CERTIFICATE OF APPROPRIATENESS

Property: 835 Columbia Street, Lots 2& 3, Block 250, Houston Heights Subdivision. The property includes a 2,429 square foot, two-story wood frame single-family residence and detached garage situated on a 13,200 square foot (100' x 132') double interior lot.

Proposal: New Construction – Residence/Garage Resubmittal

Recommendation: Approval

EAST ELEVATION – FRONT FACING COLUMBIA STREET

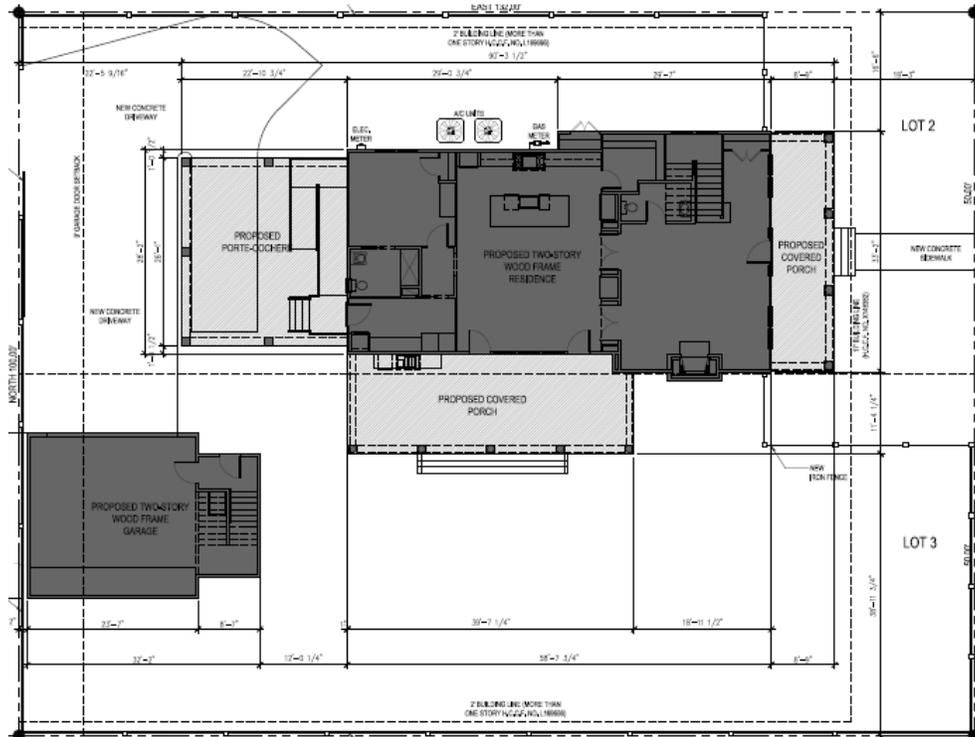
The main body of the house features Craftsman-type details, with four-over-one windows on the first floor and six lite windows in the dormer. Per staff and HAHC recommendations, the south side 12' wide by 18' deep one-story extension with an incompatible Greek Revival style was removed from the design. Therefore, the project now meets this criterion.

The proposed new residence with the south side extension had a total width of 45' that was not in scale with the contributing structures in the context area. Typical width ranges from 26' to 32' on the blockface. The removal of the 12' wide extension brought the front width of the residence to 33', which is compatible with widths on the blockface.

SOUTH SIDE ELEVATION

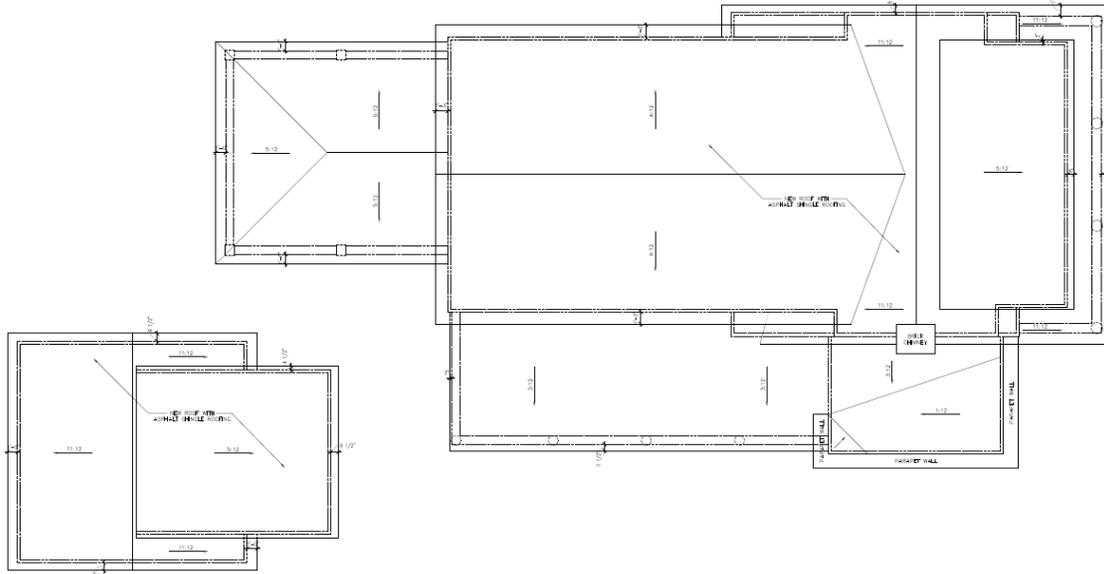
Staff requested updated drawings without the side extension to determine if the side porch had a significant visual impact on the residence. Staff has determined that the visual impact is minimal based on the transparency of the porch and the location at approximately 28' from the front. Therefore, the project meets this criterion.
